AN ORDINANCE OF THE CITY OF DESOTO, TEXAS, AMENDING THE CODE OF ORDINANCES BY AMENDING CHAPTER 3 “BUILDING REGULATIONS” BY AMENDING ARTICLE 3.100 TITLED “INTERNATIONAL BUILDING CODE” BY ADOPTING THE 2012 EDITION OF THE INTERNATIONAL BUILDING CODE WITH AMENDMENTS; BY AMENDING ARTICLE 3.200 TITLED “INTERNATIONAL PLUMBING CODE” BY ADOPTING THE 2012 EDITION OF THE INTERNATIONAL PLUMBING CODE WITH AMENDMENTS; BY AMENDING ARTICLE 3.300 TITLED “INTERNATIONAL MECHANICAL CODE” BY ADOPTING THE 2012 EDITION OF THE INTERNATIONAL MECHANICAL CODE WITH AMENDMENTS; BY AMENDING ARTICLE 3.1500 TITLED “INTERNATIONAL ENERGY CONSERVATION CODE” BY ADOPTING THE 2012 EDITION OF THE INTERNATIONAL ENERGY CONSERVATION CODE WITH AMENDMENTS; BY AMENDING ARTICLE 3.1600 TITLED “INTERNATIONAL FUEL GAS CODE” BY ADOPTING THE 2012 EDITION OF THE INTERNATIONAL FUEL GAS CODE WITH AMENDMENTS; BY AMENDING ARTICLE 3.1700 TITLED “INTERNATIONAL FIRE CODE” BY ADOPTING THE 2012 EDITION OF THE INTERNATIONAL FIRE CODE WITH AMENDMENTS AND APPENDIX I: “FIRE PROTECTION SYSTEMS – NONCOMPLIANT CONDITIONS” AND APPENDIX J: “BUILDING INFORMATION SIGN”; BY AMENDING ARTICLE 3.1800 TITLED “INTERNATIONAL RESIDENTIAL CODE” BY ADOPTING THE

Figure R602.6.1; delete the figure and insert the following figure:

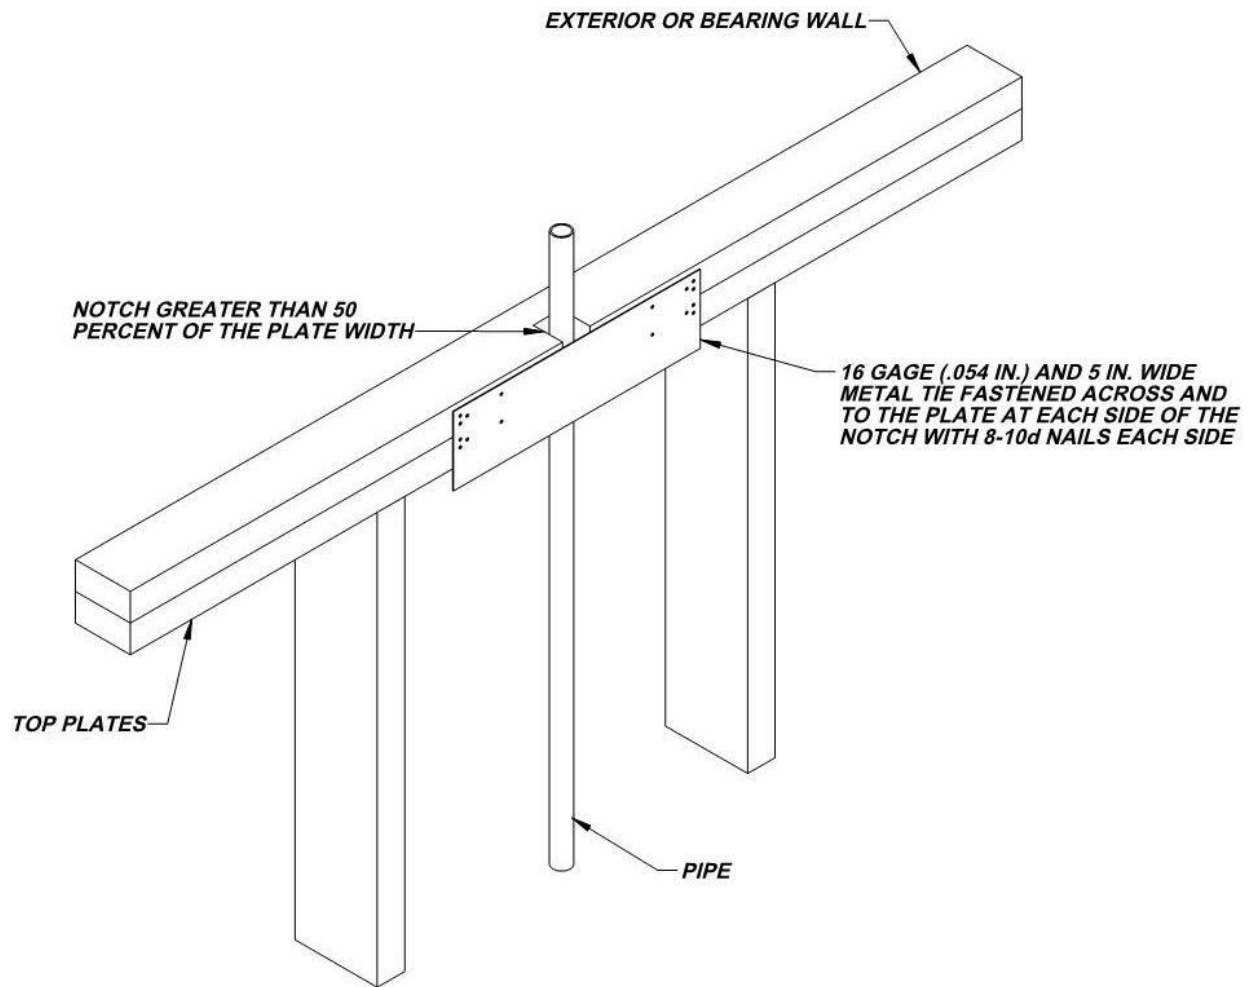
Section 602.6.1; amend the following:

R602.6.1 Drilling and notching of top plate. When piping or ductwork is placed in or partly in an exterior wall or interior load-bearing wall, necessitating cutting, drilling or notching of the top plate by more than 50 percent of its width, a galvanized metal tie not less than 0.054 inch thick (1.37 mm) (16 Ga) and ~~1½ inches (38) mm~~ 5 inches (127 mm) wide shall be fastened across and to the plate at each side of the opening with not less than eight 10d (0.148 inch diameter) having a minimum length of 1 ½ inches (38 mm) at each side or equivalent. Fasteners will be offset to prevent splitting of the top plate material. The metal tie must extend a minimum of 6 inches past the opening. See figure R602.6.1. *{remainder unchanged}*
